Air Carrier Operations Issue Area
Noise Abatement Takeoff Profiles Working Group

Task 1 – Close In and Distance Standoff Profiles

Task Assignment

MODE 3 - Altitude Loss After Takeoff

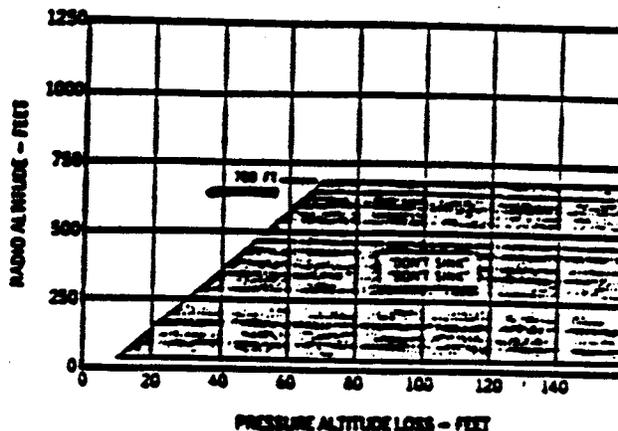
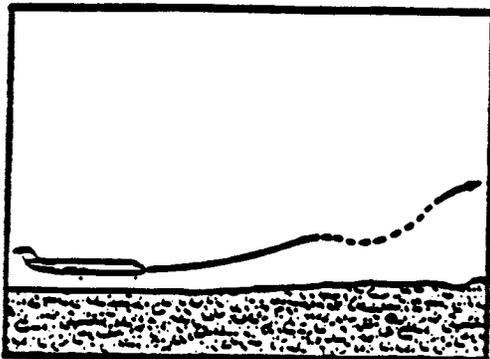
During the Reference (1) telecon, Frank Anderson offered to send information on presently certified Ground Proximity Warning Systems (GPWS), specifically warnings during takeoff. Frank stated that presently certified GPWS' provide flight crew warnings following some small amount of altitude loss during takeoff. But, to the best of our knowledge, no certified system provides warning for all altitude losses, however small. Paragraph 3(b) of Ref. (2) substantiated Frank's comment.

Both the MARK II and MARK V systems provide several ARINC defined modes of operation including Mode 3, ALTITUDE LOSS AFTER TAKEOFF. Mode 3 will be the mode of interest during takeoff noise abatement thrust cutbacks.

FIG. 1

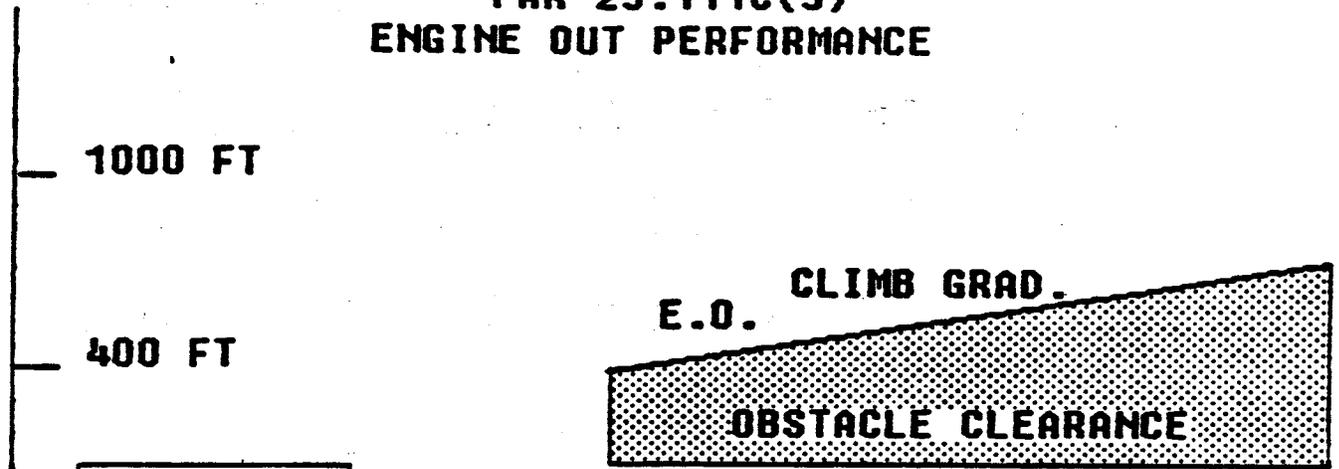
FAR 25.111c(3) specifies an engine out gradient starting at 400 ft. that provides an obstacle clearance path. (See Fig. (1)). Any close-in noise abatement takeoff with a cutback initiated above 400 ft. and the appropriate thrust restoration method can

FIG. 2

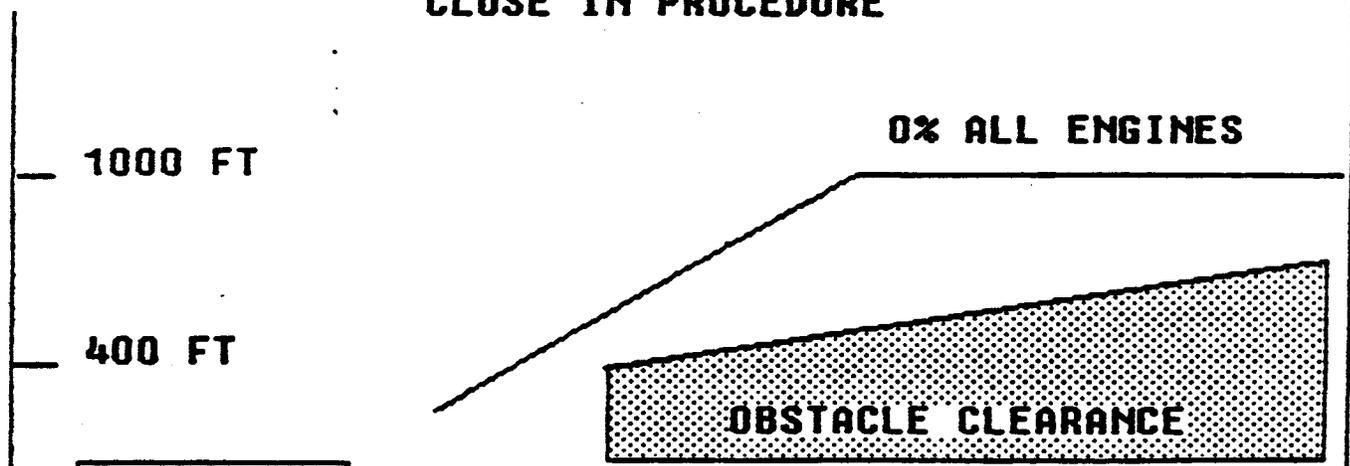
maintain the aircraft at or above the FAR 25.111C(3) obstacle clearance path. (See Fig. (2)).
